CNRO-2008-00016
May 20, 2008

SUBJECT: Relief Requests for Third 120 Month Inservice Testing interval

ASME Section XI Relief Requests

FIGURE 1
DECAY HEAT REMOVAL SYSTEM LOOP "A"

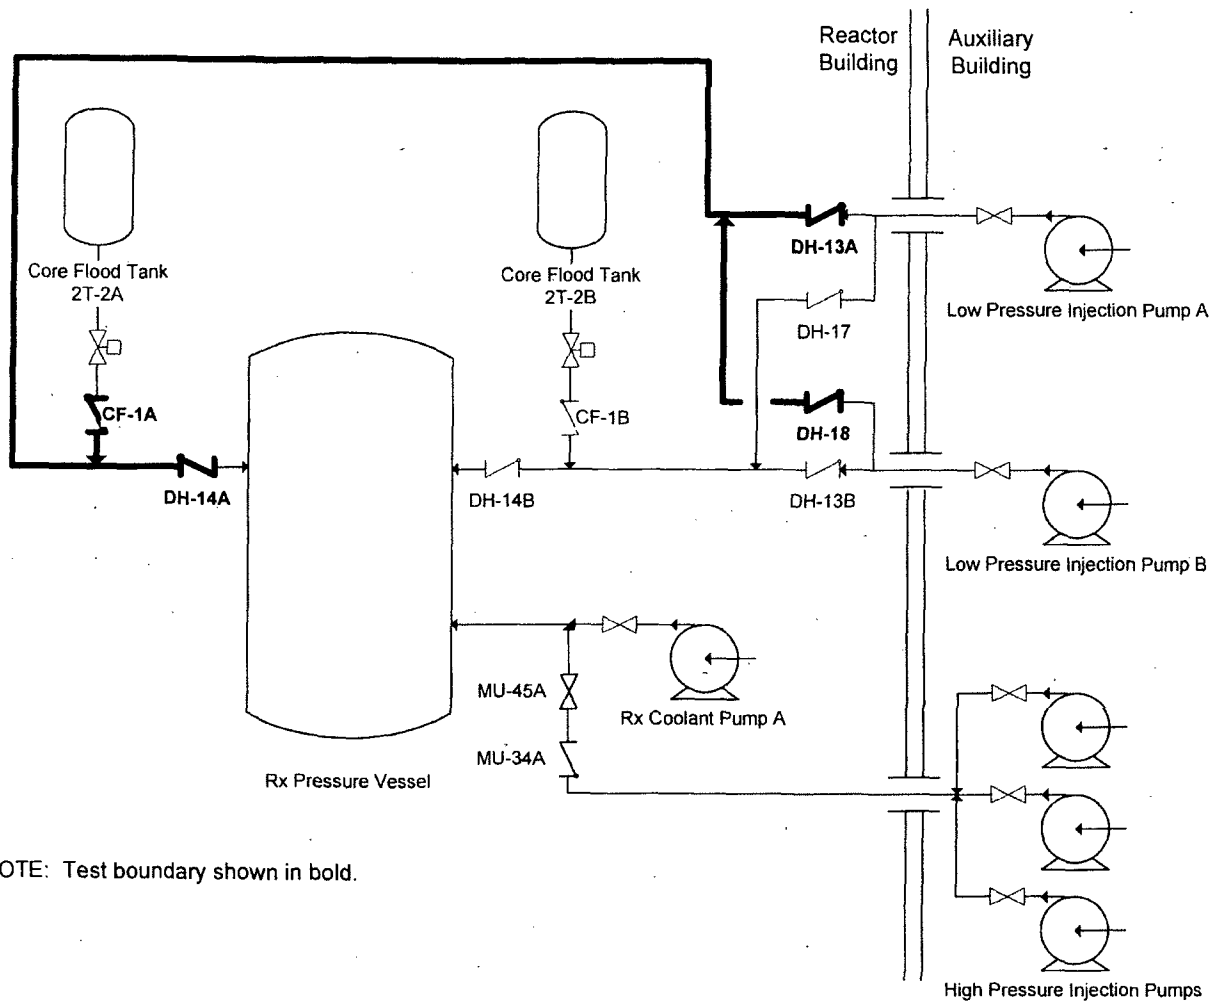
A. Decay Heat Removal Loop "A" Piping between Check Valves DH-14A, CF-1A, DH-13A and DH-18

The Decay Heat Removal Loop "A" piping and valves associated with this proposed alternative are shown in Figure 1.

The Class 2 function of the piping upstream of valve DH-14A is to provide a pathway to inject borated water from pressurized Core Flood Tank T-2A directly into the reactor vessel in the event of a loss of coolant accident (LOCA). This portion of piping between valves DH-14A, CF-1A, DH-13A and DH-18 is pressurized between 580 psig and 620 psig during normal plant operation.

Performing a ten-year Class 1 system leakage test on the extended RCPB piping of Decay Heat Removal Loop "A" between check valves DH-14A, CF-1A, DH-13A, and DH-18 involves the following actions:

The radiological dose rate in the general area of the associated piping and components is approximately 60 mrem/hr. Entergy estimates the identified actions require approximately 60 man-hours to complete resulting in a radiological exposure of approximately 3.6 man-Rem.

Pursuant to 10CFR50.55a(a)(3)(ii), Entergy requests authorization to visually examine the extended reactor coolant pressure boundary (RCPB) between the first and second normally closed isolation valves during the Class 2 system leakage test to be conducted at or near the end of the current inspection interval for the components identified in Section I, above. Section IV, below, provides the basis for applying this proposed alternative to each identified line.

FIGURE 2
DECAY HEAT REMOVAL SYSTEM LOOP "B"

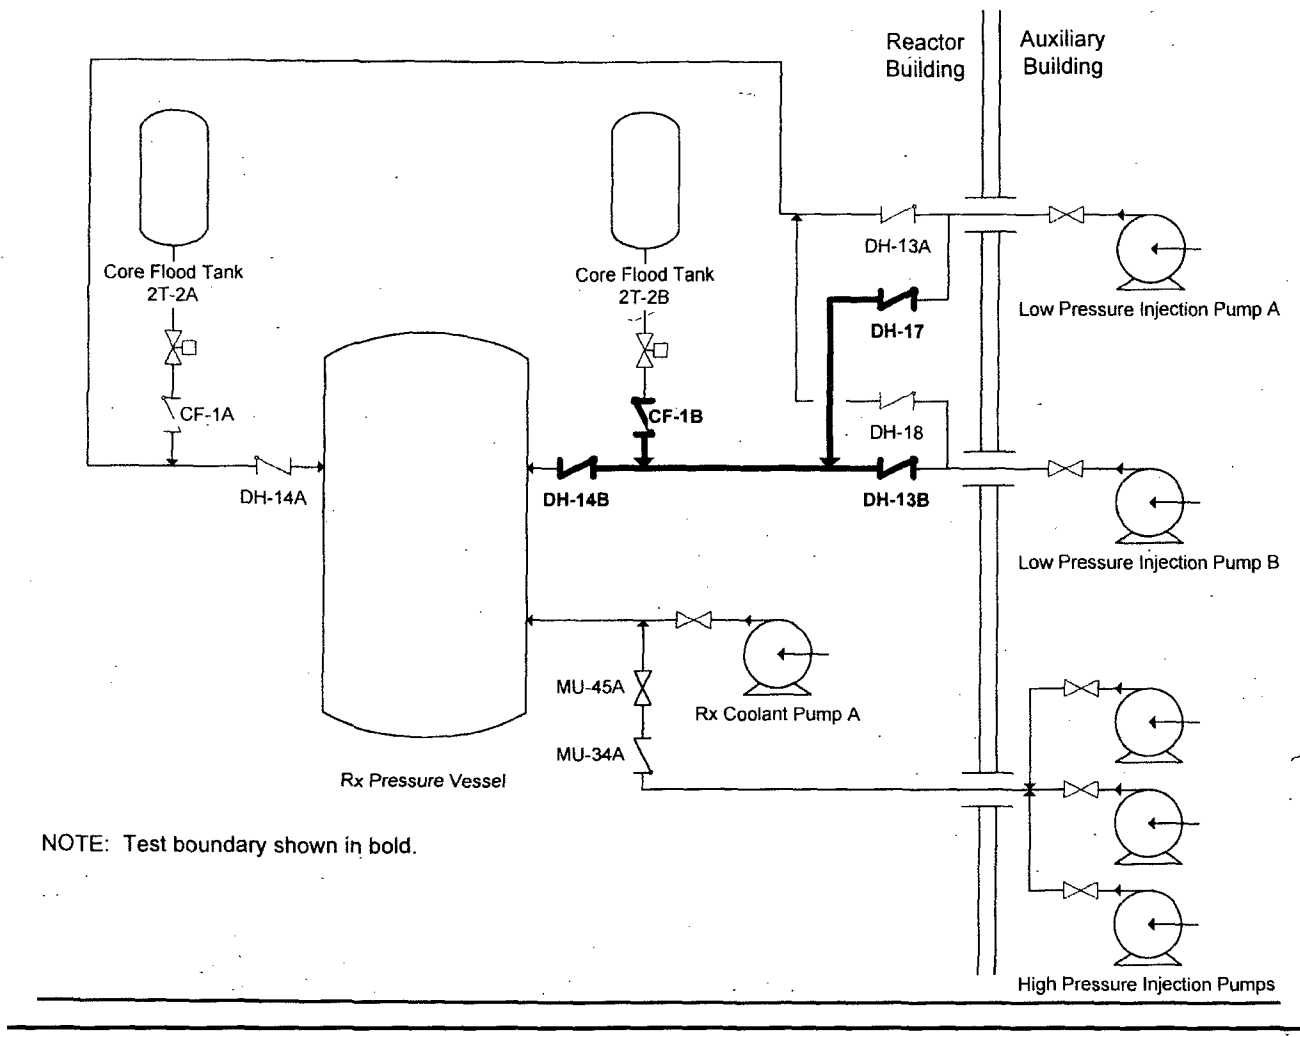
B. Decay Heat Removal Loop "B" Piping between Check Valves DH-14B, CF-1B, DH-13B and DH-17

The Decay Heat Removal Loop "B" piping and valves associated with this proposed alternative are shown in Figure 2.

The Class 2 function of the piping upstream of valve DH-14B is to provide a pathway to inject borated water from pressurized Core Flood Tank T-2B directly into the reactor vessel in the event of a LOCA. The portion of piping between valve DH-14B and valves CF-1B, DH-13B, and DH-17 is pressurized between 580 psig and 620 psig during normal plant operation.

Section IV.A, above, applied to Loop "B" piping and components. The radiological dose rate in the general area of the associated components is approximately 20 mrem/hr. Entergy estimates the identified actions require approximately 60 man-hours to complete resulting in a radiological exposure of approximately 1.2 man-Rem.

FIGURE 3
PRESSURIZER AUXILIARY SPRAY SYSTEM

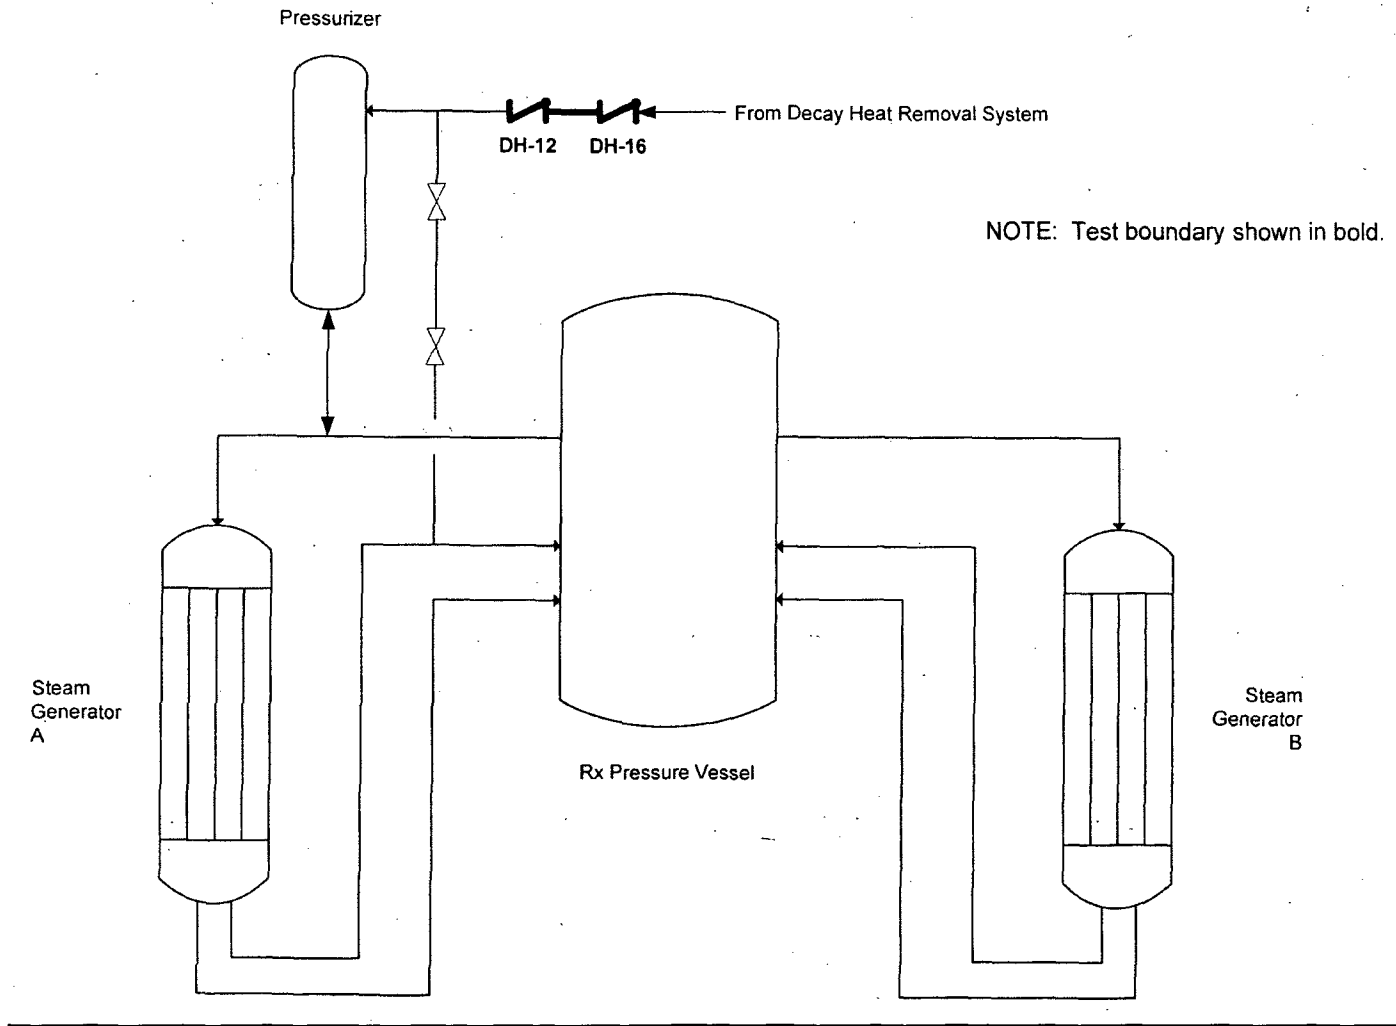
C. Pressurizer Auxiliary Spray Piping between Check Valves DH-12 and DH-16

The Pressurizer Auxiliary Spray System piping and valves associated with this proposed alternative are shown in Figure 3.

The Class 2 function of the Pressurizer Auxiliary Spray piping is to provide a boron dilution flow path to the reactor core via the pressurizer hot leg. A non-safety function provides a method to cool down and depressurize the Reactor Coolant System (RCS) using the Decay Heat Removal Auxiliary Spray System during plant shutdown. Depressurization is performed at approximately 280 psig every refueling outage. Pressurizer Auxiliary Spray is put into service to complete the RCS cooldown. While RCS is cooled down at pressures between 200 to 250 psi, the Pressurizer Auxiliary Spray line is put into service via the Decay Heat Removal System. With the Decay Heat Removal pump discharge pressure below 400 psi, Auxiliary Spray provides a continuous, small fluid volume to the reactor vessel for approximately 2 to 3 hours. Therefore, this 5-inch, non-insulated portion of the line would see approximately 280 psi during the remaining cool-down period of 2 - 3 hours.

Performing a ten-year Class 1 system leakage test on the extended RCPB piping of the Pressurizer Auxiliary Spray System piping between check valves DH-12 and DH-16 requires the same actions identified in Section IV.A, above, applied to the Pressurizer Auxiliary Spray piping and components. The section of piping between check valves DH-12 and DH-16 is 5 inches long and 1½ inches in diameter. The radiological dose rate in the general area of these components is approximately 10 mrem/hr. Entergy estimates the identified actions require approximately 40 man-hours to complete resulting in a radiological exposure of approximately 0.4 man-Rem.
